Access Compliance Report

Public Rights-of-Way

Intersection ID: 30060	Main Street: DILLARD RIDGE DR	Cross Street: WATERS TRAIL DR	Location:	N
ADA ID: 9A3F938CAE77	Ramp Type: BlendTrans2	Initial Pass/Fail: Pass	Overall Compliance: No	Severity Score: 0
Codes/Mitigation Info/Possible Solution		Field Measurements/Component Compliance

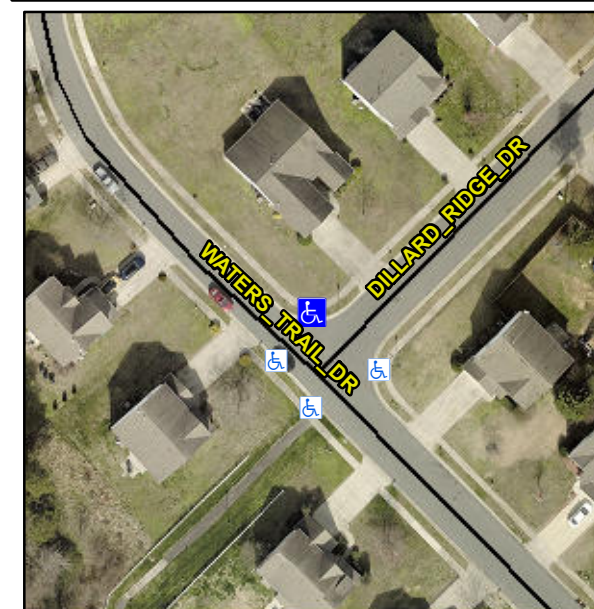
CURB GAP 1.0, RAMP LIP 1.0, CURB WIDTH 31.0

Not Found, R305.2

N/A	Ramp inside XWalk1?	N/A	N/A	Ramp inside XWalk2?	N/A
	Road Slope (%)	1.6		Clear Space?	Yes
	Road X Slope (%)	5.2	N/A	Clear Space to XWalk (in)	N/A
Yes	Any Obstructions?	No	Yes	Storm Grate/Utility Hazard?	No
	Obstruction Type			Storm Grate/Utility Type	
		N/A			N/A
			Yes	Surface Condition? (G/P)	Good
			No	Curb Slope (%)	22.1

Remove & Replace Curb Ramp With Two New Directional Ramps or Equivalent.
